Delegated Report

Application No: 20211326

Location: Cumloden, Pear Tree Lane, Shorne DA12 3JZ

Description: Application for approval of conditions 4 and 6 attached to planning permission reference number 20190755 relating to the soft and hard landscaping scheme to front (4) and land reserved for parking (6).

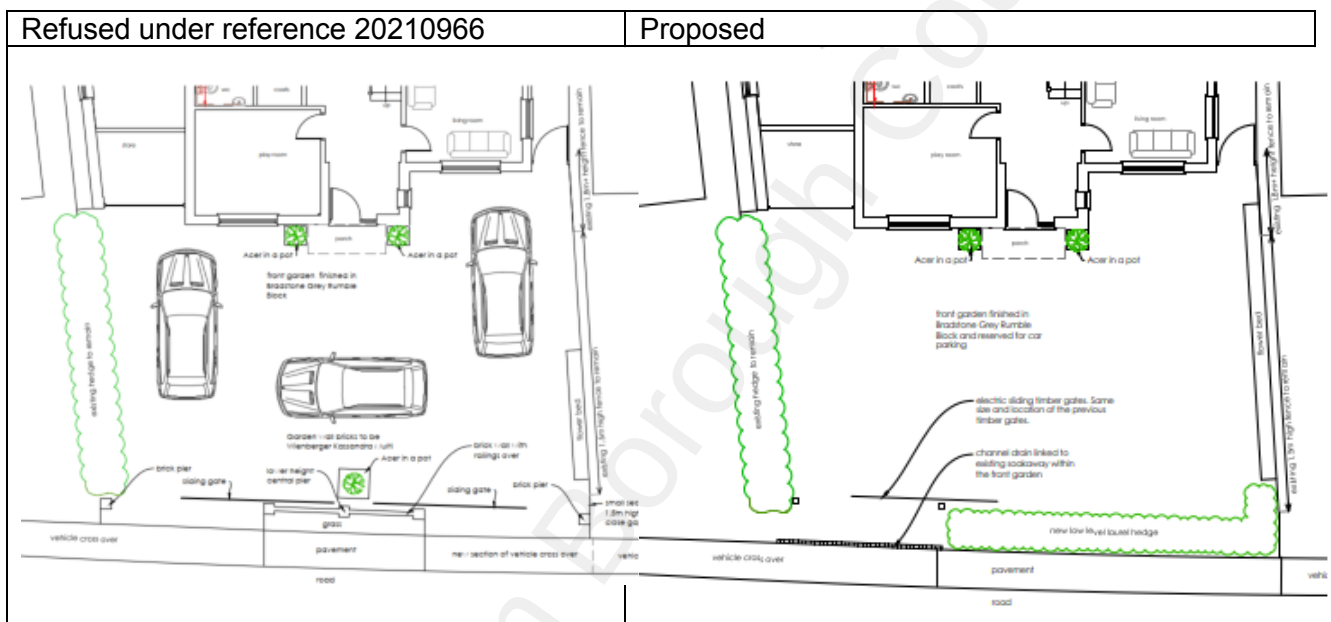
2) **Location of the hedge and soakaway, and clarification of the depth of the highway verge:** The proposed 1m high laurel hedge is shown planted right up to the edge of the pavement whereas we believe that this encroaches on the highway verge as shown on the KCC Highways street plans. Similarly for the position of the proposed channel drain.

We note that the photographs supplied by the applicant show that the original wooden gate was in line with the fence of the house immediately to the east, as in accordance with the KCC Highways street plans. The previous hedge was very overgrown and had encroached onto the Highway verge.

We believe that the proposed hedge should be planted in a bed that is fully behind the original gate line and the continuation of the line of the fence from the next door east property to the forward end of the dividing fence to Clearways, however this must be clarified with KCC Highways.
